Access Compliance Report

Public Rights-of-Way

(Pedestrian Signals)

Intersection ID: N/A	Main Street:	Cross Street: N/A	Location: N/A
ADA ID: 190C093CEAB2	Signal Type: Two Push Buttons-APS	Overall Compliance: No	Severity Score: BTN 1:N/A BTN 2: N/A No BTN: N/A
Codes/Mitigation Info/Possible Solution		Field Measurements/Component Compliance

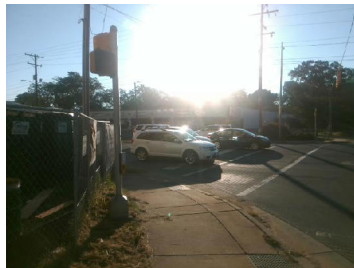
PROW/ADA: TMUTCD 4e.08, R404.3, R404.1, R406.2,

N/A	B 1 FWD Approach Obstruction?	Yes	N/A	B 2 FWD Approach Obstruction?	Yes
N/A	B 1 FWD Approach Obstruction Dist (in)	7.0	N/A	B 2 FWD Approach ObstructionDist (in)	7.0
N/A	B 1 PARA Approach?	No	N/A	B 2 PARA Approach?	Yes
N/A	B 1 PARA Approach Constrained?	N/A	N/A	B 2 PARA Approach Constrained?	No
N/A	B 1 PARA Approach Reach (in)	N/A	Yes	B 2 PARA Approach Reach (in)	7.0
N/A	B 1 PARA Approach Width (in)	N/A	N/A	B 2 PARA Approach Width (in)	N/A
N/A	B 1 PARA Approach Obstruction?	N/A	N/A	B 2 PARA Approach Obstruction?	Yes
N/A	B 1 PARA Approach Obstruction Dist (in)	N/A	N/A	B 2 PARA Approach ObstructionDist (in)	7.0
N/A	B 1 Clear Floor Space Slope (%)	N/A	N/A	B 2 Clear Floor Space Slope (%)	N/A
N/A	B 1 Clear Floor Space XSlope (%)	N/A	N/A	B 2 Clear Floor Space XSlope (%)	N/A
N/A	B 1 PAR Slope (%)	0.3	N/A	B 2 PAR Slope (%)	0.1
Yes	B 1 Height (in)	40.0	Yes	B 2 Height (in)	40.0
Yes	B 1 Pressure (#)	2.0	Yes	B 2 Pressure (#)	2.0

Yes	B 1 Clear Xing Direction?	ClearlyMarked	Yes	B 2 Clear Xing Direction?	ClearlyMarked
	B 1 Crossing Direction	To SW		B 2 Crossing Direction	To SE
Yes	B 1 DistanceTo XWalk (in)	0.0	Yes	B 2 DistanceTo XWalk (in)	0.0
No	B 1 DistanceTo Curb (in)	92.0	No	B 2 DistanceTo Curb (in)	92.0
Yes	B 1 Diameter (in)	2.0	Yes	B 2 Diameter (in)	2.0

Possible Solutions: Replace Signal Push Button With APS Button on New Post. Remove & Relocate Sign.
